ADiS IMU 44X47X14 Package Outline Drawing
(First used on ADiS16375)

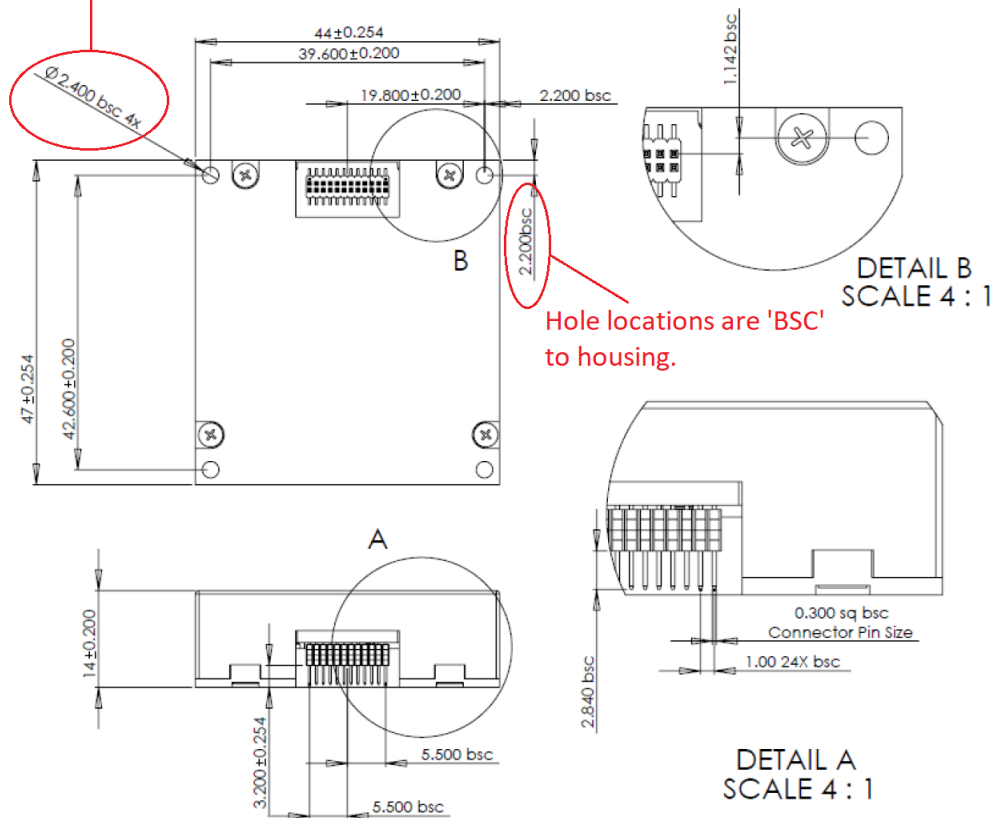
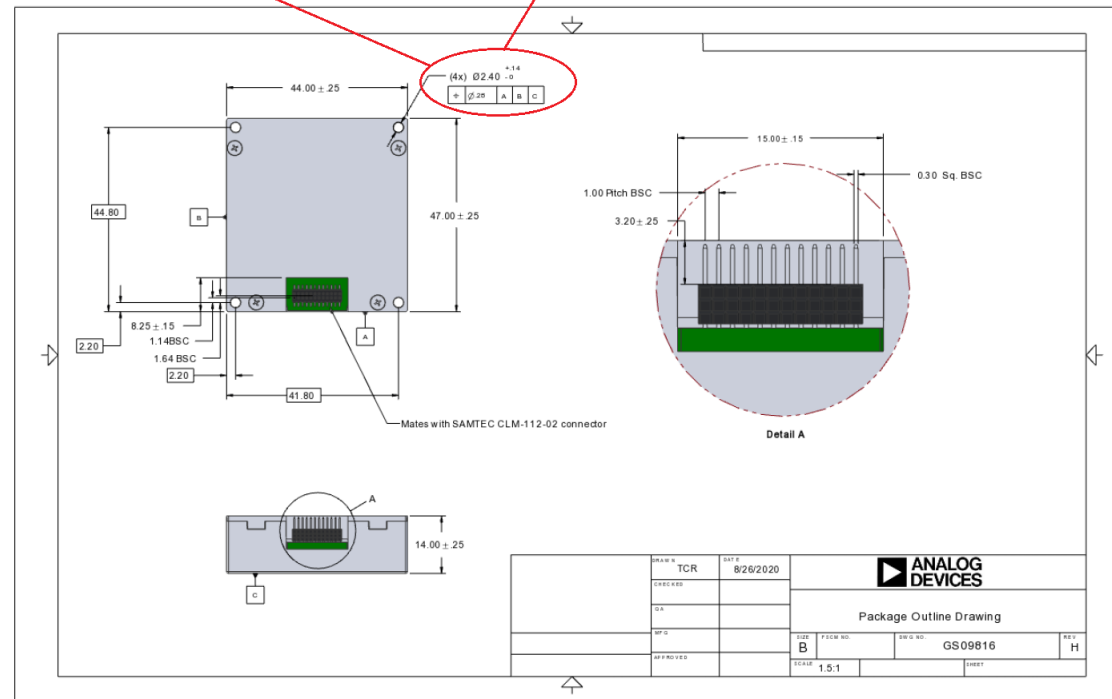
Hole diameters are not
toleranced (BSC)

Mounting hole diameters are
toleranced.
(from a non-tolerance)

Utilizes GD&T to accurately locate
mounting holes. Holes are in same location.

These changes allow customers to accurately and repeatably
place the mating fastener Holes. This has been at our primary
customer's request.
